Subject: 20160 Mack Avenue: Conditional Rezoning (Map Amendment), Review #2
Parcel ID: 009-01-0001-000
Current Zoning: RO-1, Restricted Office District
Proposed Rezoning: C, Commercial Business District (Conditionally)

Conditional Rezoning Review

MIXED-USE
DEVELOPMENT

20160 Mack Ave, Grosse
Pointe Woods, MI 48236

The 2024 Master Plan's Future Land Use Map (Pg 65 of Master Plan).

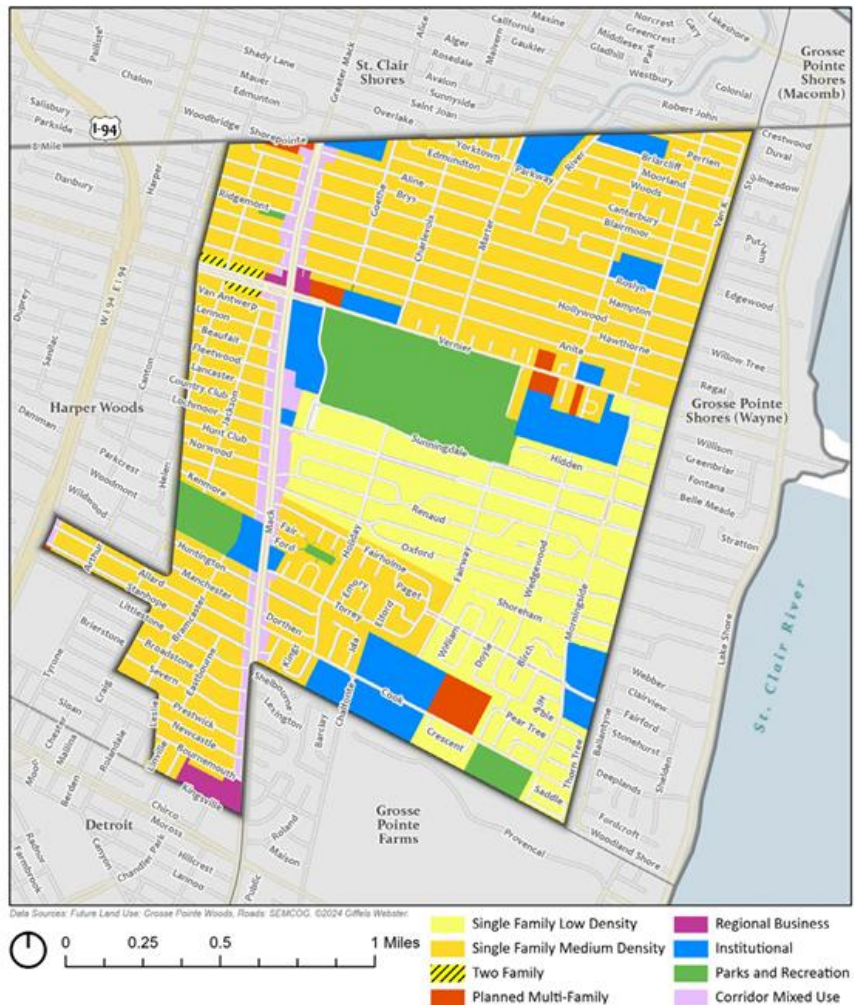
Second, this rezoning is consistent with the 2024 Master Plan's Future Land Use Map, which designates this area as *Corridor Mixed Use*.

This is described in the text of the Master Plan as, “*This land use designation includes retail, restaurant, personal service, and office establishments which are designed for the day-to-day needs of nearby residents and are found along the Mack Avenue corridor and along its easternmost boundary of Harper Avenue that extends one-and-a-half blocks between Stanhope Street and just north of Allard Avenue. These facilities are intended to be located in close proximity to residential neighborhoods but with adequate buffering. These land uses equate to the City's C Commercial zoning district, P Parking district and some areas zoned RO-1 Restricted Office*”.

1 SITE PLAN
A1 1" = 20'-0"

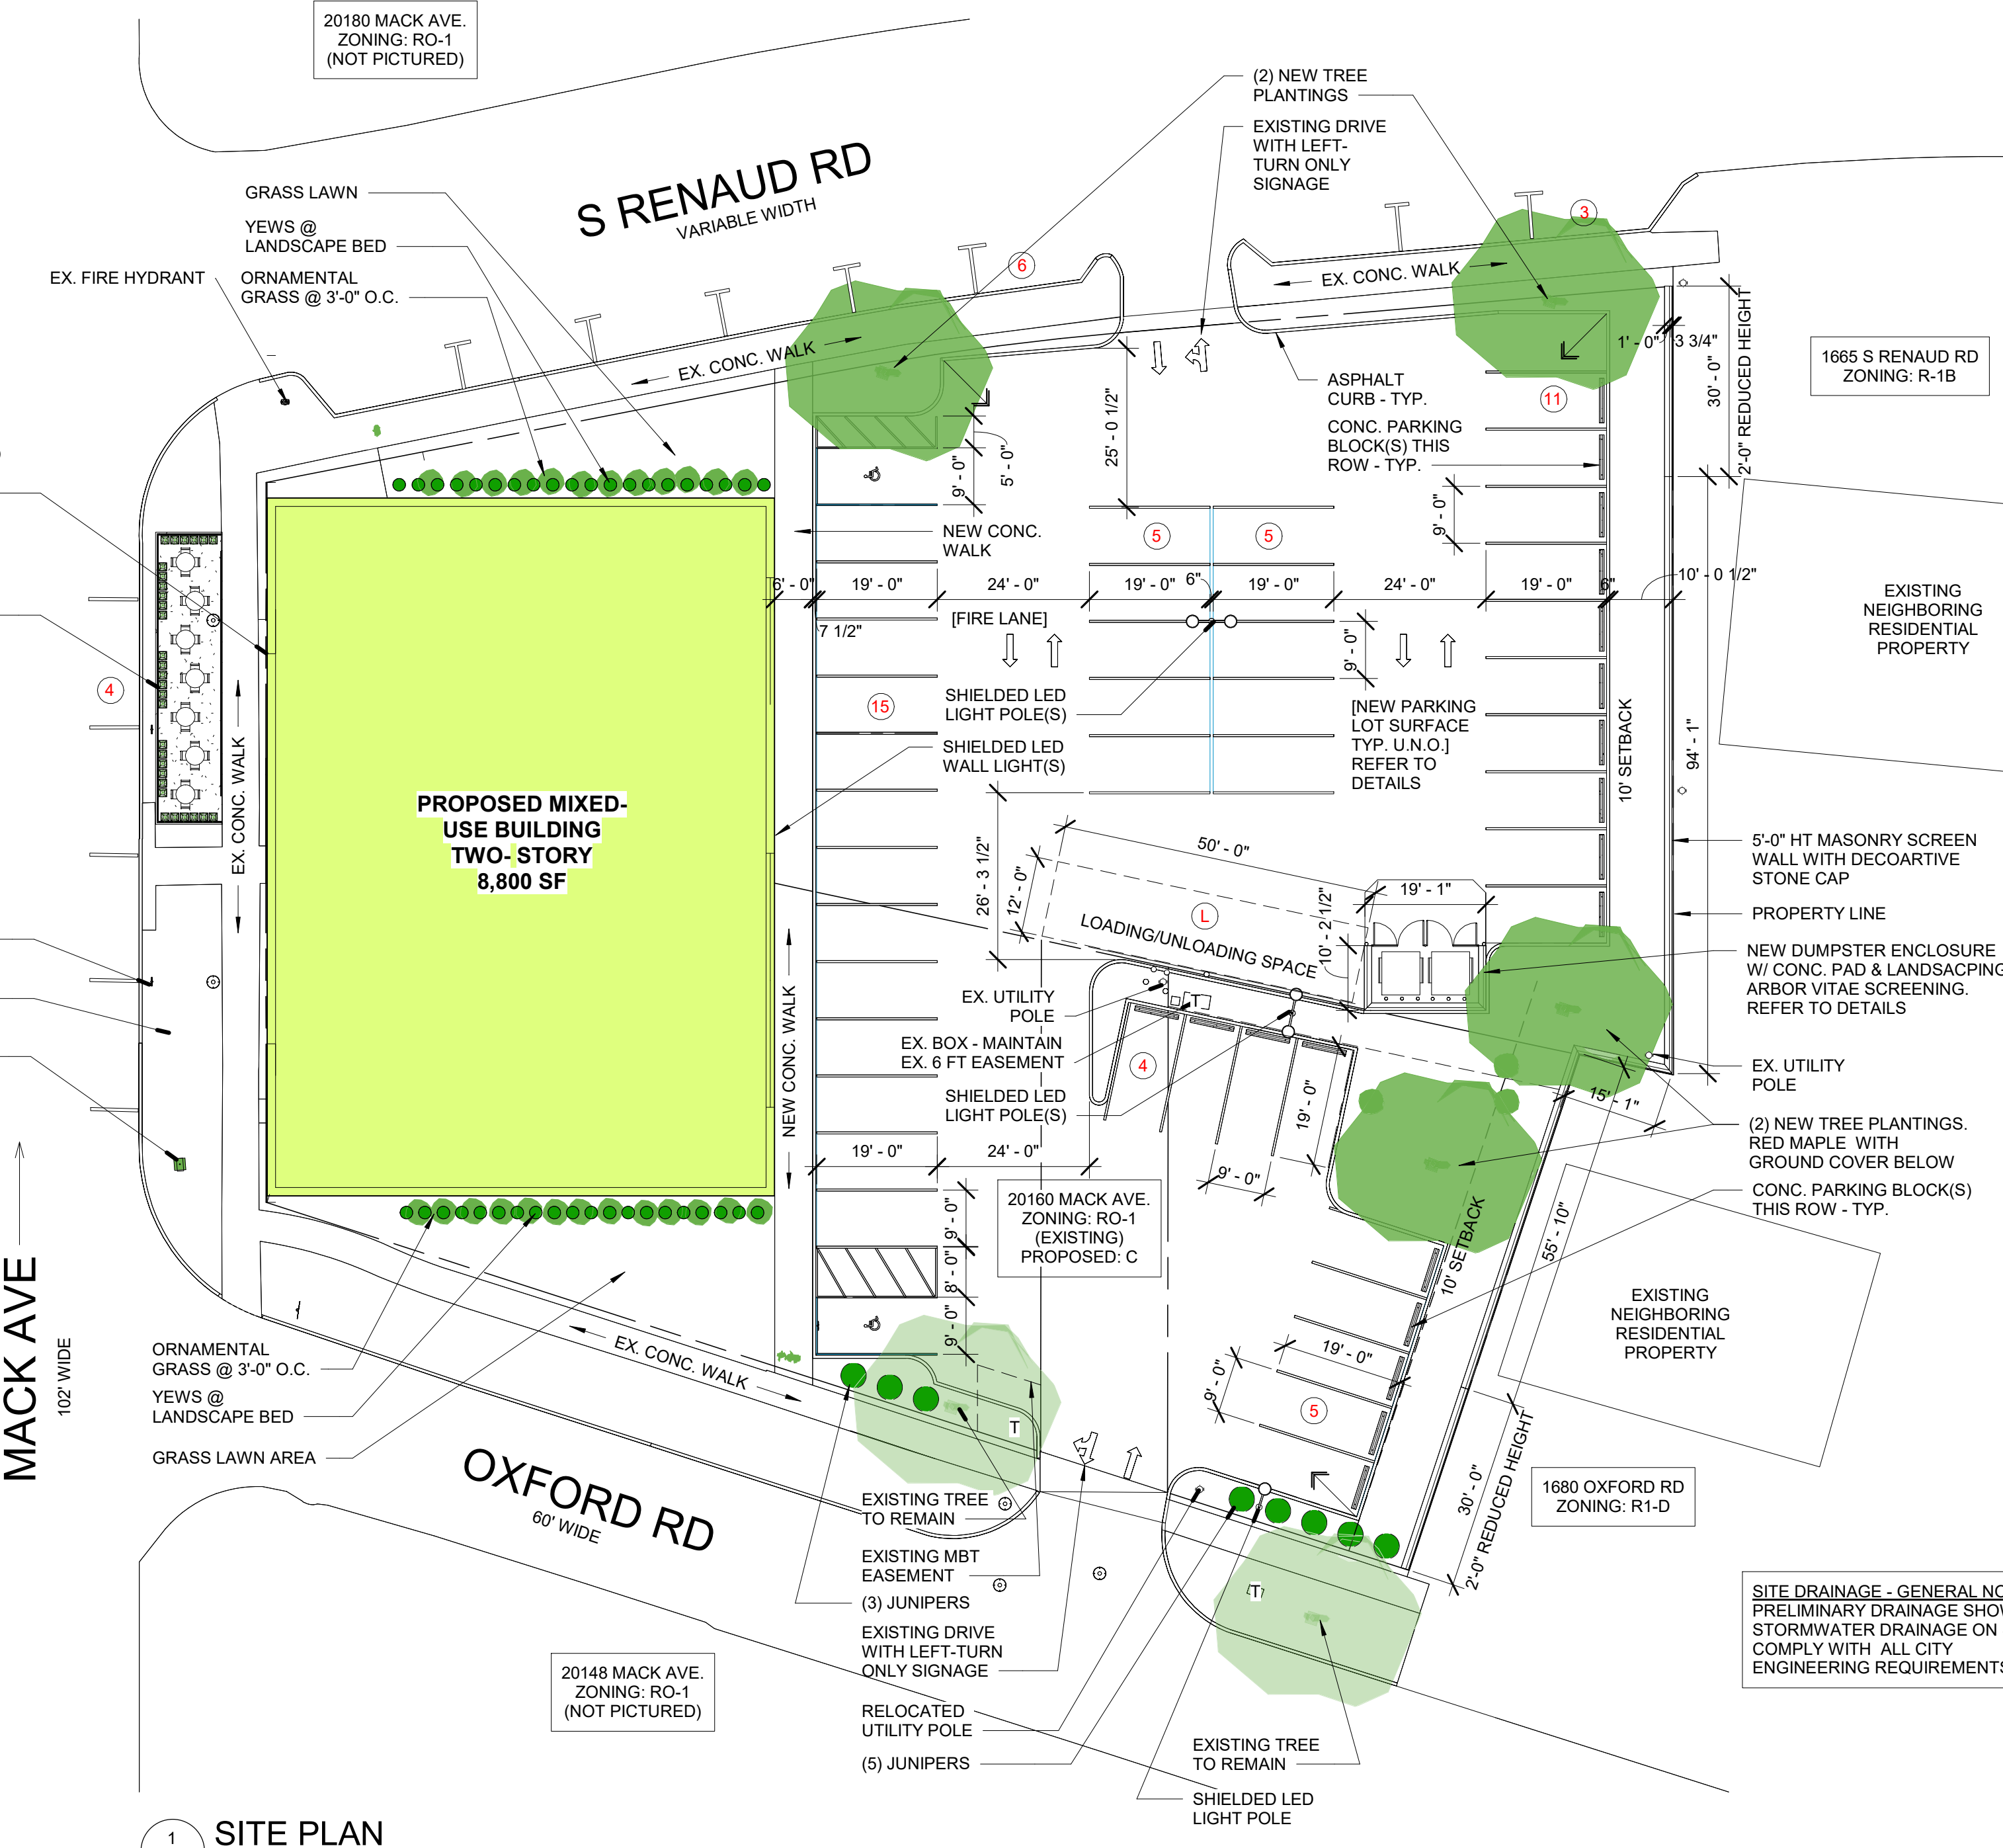
As detailed on the site plan, the proposed parking spaces comply with the minimum required dimensions of 9 ft. by 19 ft., and a 12 ft. by 50 ft. loading zone is proposed (in compliance).

Lastly, Section 50-5.3(U) requires that parking lots provide traffic lane markings to indicate entrances and exits, and to provide for the safe and orderly movement of vehicles. These required traffic lane markings are depicted on the plans. This includes markings on the ingress/egress from S. Renaud Road and on Oxford Road, as well as within the parking lot itself, as well as the inclusion of signage to bar turns onto the adjoining residential streets.

For landscaping, the applicant proposes ornamental grasses and grass lawns adjacent to the proposed building, as well as four new planted trees. A screening wall is proposed along the eastern side of the property, where the site abuts two residential properties. Currently, the screening wall proposed at the east side of the site exceeds maximum height restrictions. To reach compliance with the screening wall requirements, the applicant would need to reduce the masonry wall height to 4 feet or submit for and receive a variance for a taller masonry wall. The screening of the subject site will be determined during the site plan review process.
